QUALITY ASSURANCE -- NON-CONFORMANCE REPORT

Report No: NCR-000364

Reference Description: Non-conforming welding repairs FB Diaphragm

Job Name: SAS Superstructure

关键焊缝返修报告 ical Welding Repair Report (CWR)				版本 Rev. No.: 1	
项 Project Name:	SFOBB	部件图号 Drawing No.:	SEG014 SEG016	报告编号 Report No.:	B-CWR596
合同号 Contract No.:	04-0120F4	部件名称 Item Name:	OBG PLATE PANEL SPLICE	NDT 报告编号 NDT Report No.:	B787-MT-11930
项目编号 Project No.:	ZP06-787

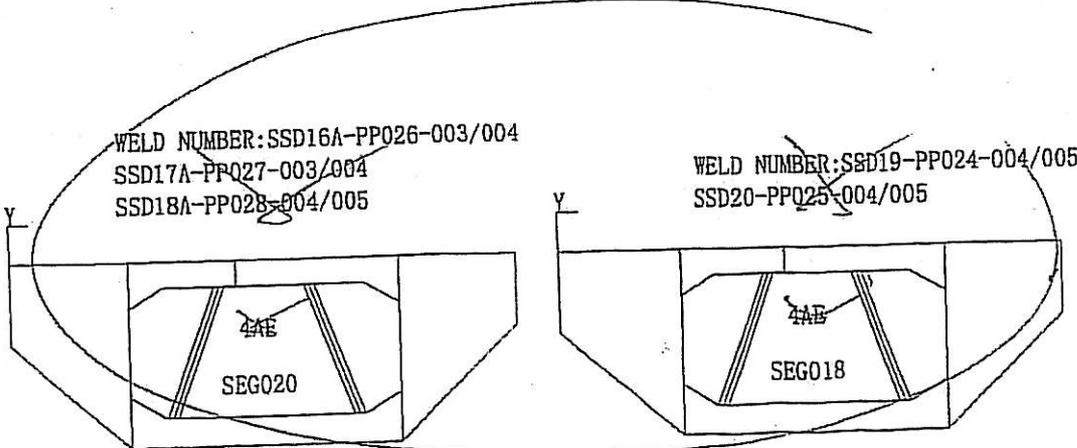
焊缝缺陷描述:
Description of Welding Discontinuity:
 Five cracks were found by use of MT on weld SSD19-PP023-004 Welder ID No.058551 Position:2F
 Twelve cracks were found by use of MT on weld SSD19-PP023-005 Welder ID No.047866 Position:2F
 Two cracks were found by use of MT on weld SSD15-PP019-003 Welder ID No.058551 Position:2F
 Twelve cracks were found by use of MT on weld SSD15-PP019-004 Welder ID No.050242 Position:2F
 Fourteen cracks were found by use of MT on weld ~~SSD16-PP020-003~~ Welder ID No.058551 Position:2F
 Two cracks were found by use of MT on weld SSD16-PP020-004 Welder ID No.050242 Position:2F
 Seventeen cracks were found by use of MT on weld SSD17-PP021-003 Welder ID No.058551 Position:2F
 Thirty cracks were found by use of MT on weld SSD17-PP021-004 Welder ID No.050242 Position:2F
 Nine cracks were found by use of MT on weld SSD18-PP022-004 Welder ID No.058551 Position:2F
 Twenty-three cracks were found by use of MT on weld SSD18-PP022-005 Welder ID No.050242 Position:2F

WRONG PICTURE 3AE & 3BE

- Hardness testing is reqd at every location where the trans. cracks found. The readings of the test shall be done along the weld and adj. base metal. Provide written & verbal notification to the engr. prior to the hardness testing for engr. to witness the testing. (Ref TC-20 for further remarks)

处理意见: *- The result of the hardness testing shall be submitted to CT for review prior to repairing*

- Disposition: *for review prior to repairing*
1. 工程师通知到现场, 缺陷返修按照角焊缝返修程序; *- Separate CWR approval is needed if*
 2. 这次返修时, QC和Leader CWI到现场指导打磨, 焊接和监控的指导工作; *cracks are found in*
 3. 整个返修的过程, QC和Leader CWI应该有批准CWR的复印件; *the base metal HAZ.*
 4. QC和Leader CWI指导返修, 以保证返修按照处理意见进行;
 5. 在要求做MT的区域去除油漆; *- If excessive root gap (5mm or more) is found during grinding of the*
 6. 采用打磨的方式去除裂纹; *repair area, the Contractor shall seek eng's*
 7. 准备一个正确的接头型式, 具体参照相应的返修WPS; *approval. (see TC-20 for further remarks)*
 8. 返修前, VT和MT检测确认返修区域没有裂纹, 同时靠近横向裂纹的母材也要做MT, 也保证没有裂纹延伸到母材;
 9. 根据批准的返修焊接工艺规程预热及焊接。
 10. 将修补区域打磨与母材或相邻焊缝平齐;
 11. VT检测焊缝, 按照标书10-1.59中的备注3的额外DNT要求进行检测;
 12. 返修后对所有的焊缝进行100%的MT检测, 包括返修的反面, 以前没有返修的区域。

1. The Engineer shall be notified and present during this repair. Indicate repair procedure, if fillet weld;
2. QC and a Lead CWI shall be present and direct all gouging, grinding and welding operations during this repair. *- gouging shall not be used for this repair*

3. QC and a Lead CWI shall have an approved copy of the CWR in hand prior to the repair.
4. QC and a Lead CWI shall direct the repair to ensure the repair is per the disposition requirements.

项目名称 Project Name	美国海湾大桥 SFOBB	部件图号 Drawing No	SSD17A	报告编号 Report No.	B-WR6736
合同号 Contract No.:	04-0120F4	部件名称 Items Name	3AE PLATE .PANEL SPLICE	NDT报告编号 Report No.of NDT	B787-UT-7962
项目编号 Project No.:	ZP06-787

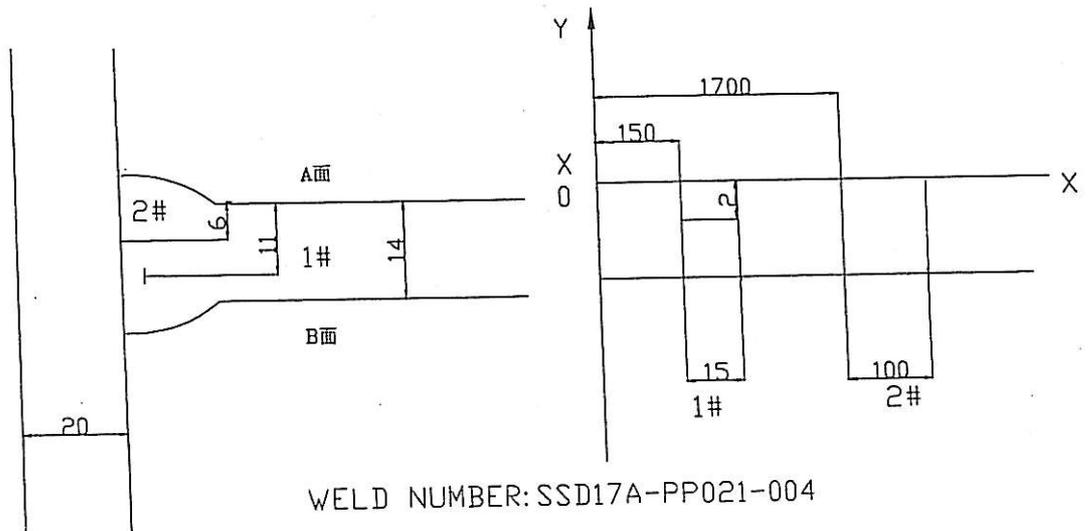
Rejected indication found by ultrasonic inspection is less than the maximum allowance aggregate length.

(UT探伤发现的缺陷总长度小于最大允许长度。) SSD17A-PP021-004

1. Gouge or grind from nearer side from metal edge ($D \leq 0.65T$, "D" is depth of defects, "T" is thickness of metal) to remove all defects;

3. Verify with VT no defects remain in the weld joint prior to welding;

项目名称 Project Name	美国海湾大桥 SFOBB	部件图号 Drawing No	SSD18A	报告编号 Report No.	B-WR6776
合同号 Contract No.:	04-0120F4	部件名称 Items Name	3AE PLATE PANEL SPLICE	NDT报告编号 Report No.of NDT	
项目编号 Project No.:	ZP06-787				B787-UT-7980

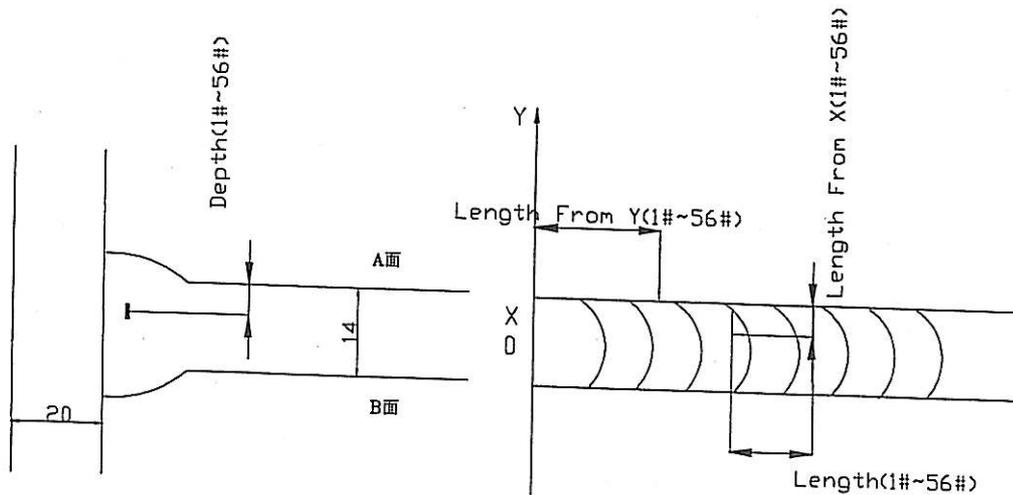
Rejected indication found by ultrasonic inspection is less than the maximum allowance aggregate length.

(UT探伤发现的缺陷总长度小于最大允许长度。) SSD18A-PP022-004

1. 从缺陷距离端面较近一侧 ($D \leq 0.65T$, D 为缺陷深度, T 为板厚) 采用碳刨或打磨的方法去除焊缝缺陷;
 2. 参照返修焊接工艺规程 (WPS) 准备正确的接头型式, 预热和焊接;
 3. 焊前对修补区域进行VT检测保证缺陷完全被清除;
 4. 将修补区域打磨到与母材或邻近焊缝平齐;
 5. 根据批准的车间图纸检查焊缝.
-
1. Gouge or grind from nearer side from metal edge ($D \leq 0.65T$, "D" is depth of defects, "T" is thickness of metal) to remove all defects;
 2. Follow repair WPS for joint preparation, preheat, and weld deposit;
 3. Verify with VT no defects remain in the weld joint prior to welding;
 4. Grind the repaired area flush with base metal or the adjacent weld;
 5. Check the welds according to the working drawings.

项目名称 Project Name:	美国海湾大桥 SFOBB	部件图号 Drawing No.:	SSD17A	报告编号 Report No.:	E-CWR651
合同号 Contract No.:	04-0120F4	部件名称 Item Name:	3AE PLATE PANEL SPLLICE	NDT 报告编号 NDT Report No.:	B787-MT-12710
项目编号 Project No.:	ZP06-787

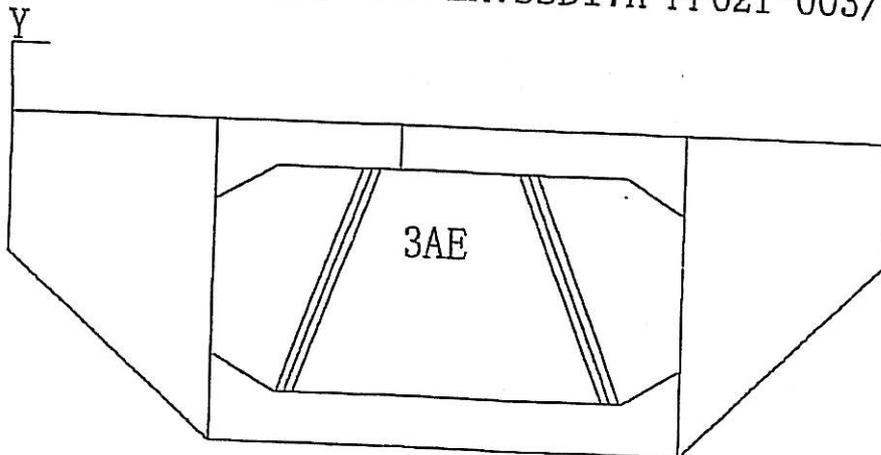
Welder ID No. (焊工编号): 050242 044801 055791 Position:(位置): 2G

2. QC and a Lead CWI shall have an approved copy of the CWR in hand prior to the repair.
 3. Remove paint ≥ 25 mm in all direction of HAZ prior to MT.
 4. Remove cracks by grinding, repair area shall extend a minimum of 50mm beyond each end of single crack repairs, and 50mm beyond the outermost cracks for multiple crack repairs.

6. Prepare excavation in accordance with an approved repair WPS prior to welding.
 7. Before this repair, Verify with VT and MT repair areas are defects free, and also MT shall be performed on the base metal laying abroad cracks to ensure that no cracks were propagated to the base metal. Separate CWR approval is needed if cracks are found in the base metal before continuing welding repair procedures.

项目名称 Project Name:	美国海湾大桥 SFOBB	部件图号 Drawing No.:	SSD18A	报告编号 Report No.:	B-CWR658
合同号 Contract No.:	04-0120F4	部件名称 Item Name:	3AE顶板连接板 3AE PLATE PANEL	NDT 报告编号 NDT Report No.:	B787-MT-12822
项目编号 Project No.:	ZP06-787		SPLICE

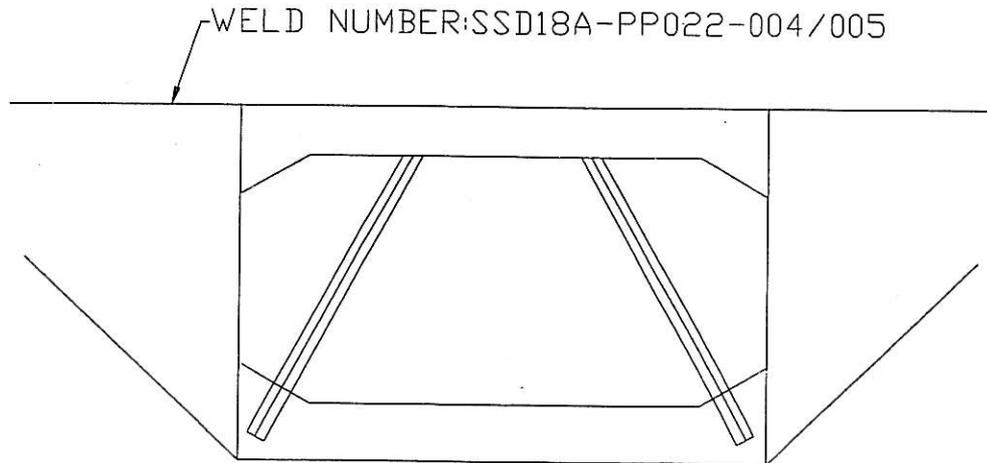
Three transverse cracks and six longitudinal cracks were found by use of MT on SSD18A-PP022-005.

Two welds joint has changed to CJP welds, and the cracks were found during final MT.

2. QC and a Lead CWI shall have an approved copy of the CWR in hand prior to the repair.
 3. Remove paint ≥ 25 mm in all direction of HAZ prior to MT.
 4. Remove cracks by grinding, repair area shall extend a minimum of 50mm beyond each end of single crack repairs, and 50mm beyond the outermost cracks for multiple crack repairs.

5. Prepare excavation in accordance with an approved repair WPS prior to welding.
 6. Before this repair, Verify with VT and MT repair areas are defects free, and also MT shall be performed on the base metal laying abroad cracks to ensure that no cracks were propagated to the base metal. Separate CWR approval is needed if cracks are found in the base metal.
